REACTOR FACILITY

May 7, 1985

In response to your letter dated June 22, 1984 RRF requests that the following changes be made to our previously submitted Emergency Plan.

Floor Plan of Reactor Facility

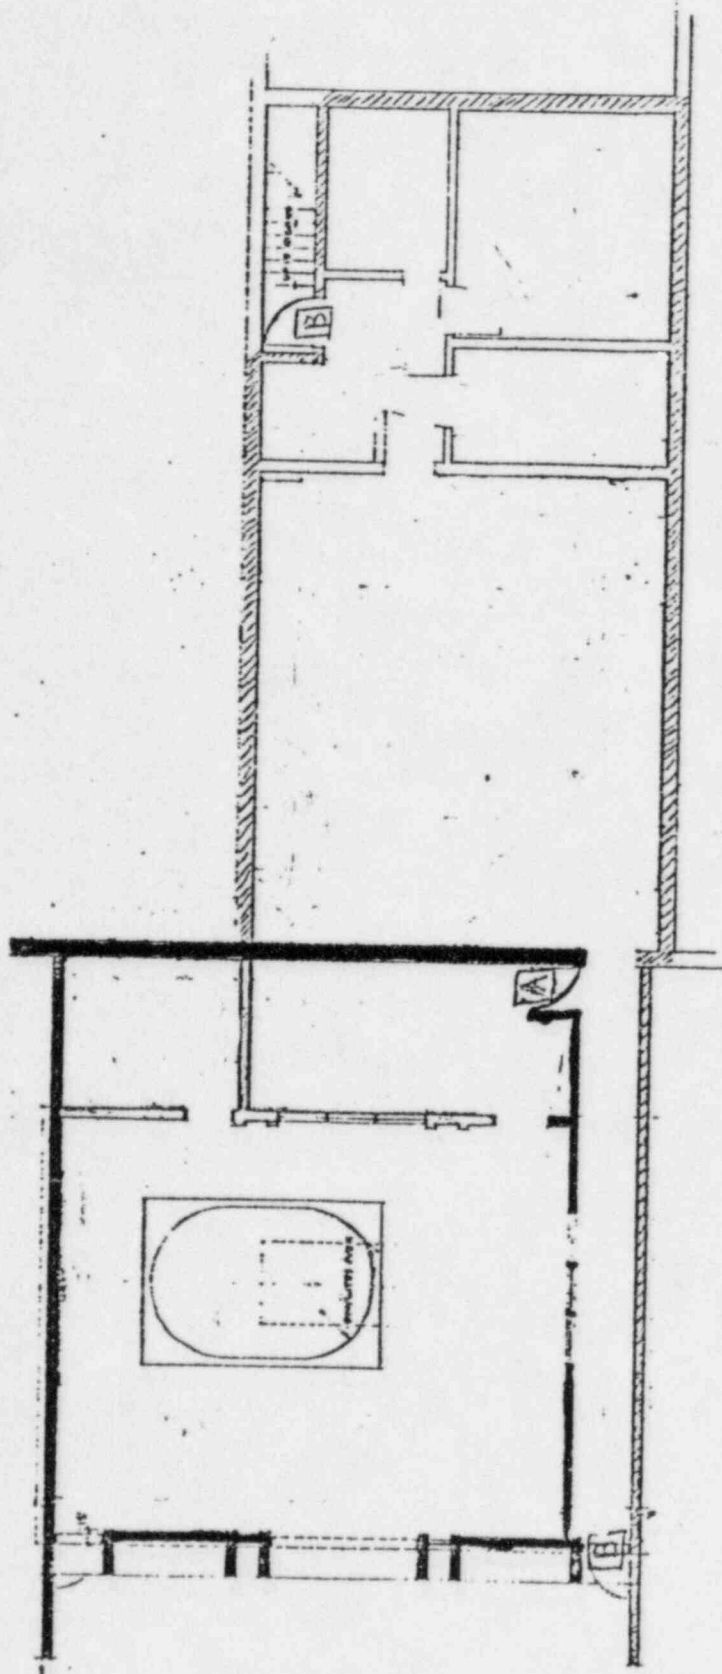
Change the existing definition of Operations Boundary and Site Boundary with,

"OPERATIONS BOUNDARY - The area within the site boundary as shown in the floor plan of the Reed Reactor Facility is the operations boundary. When the door labeled 'A' is closed it consists of the area outlined in black. When the door labeled 'A' is open the operations boundary is expanded to include the area outlined in hatched lines. Within the operations boundary the reactor chief administrator has direct authority over all activities. The area within this boundary shall have prearranged evacuation procedures known to all personnel frequenting the area.
